Access Compliance Report

Public Rights-of-Way

| Intersection ID: 10020348 | | Main Street: BALLANTYNE COMMONS PY | | Cross Street: N/A | | Location: | | SE | |
| ADA ID: 797BBD469E2B | | Ramp Type: Perp | | Initial Pass/Fail: Fail | | Overall Compliance: No | | Severity Score: 60 | |

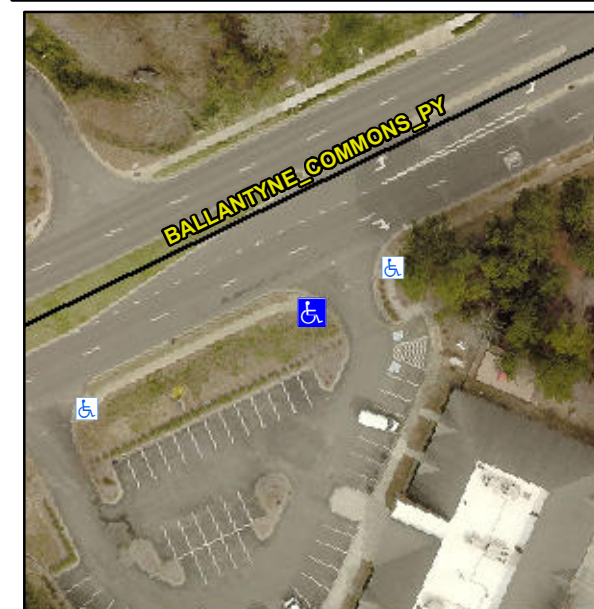
Not Found, R304.5.1, R304.5.3

| Compliance | Description | Data | Compliance | Description | Data |
|------------|-----------------------|-------|------------|-----------------------------|------|
| No | Ramp Width (in) | 29.0 | No | Ramp XSlope (%) | 10.8 |

Remove & Replace Entire Ramp.
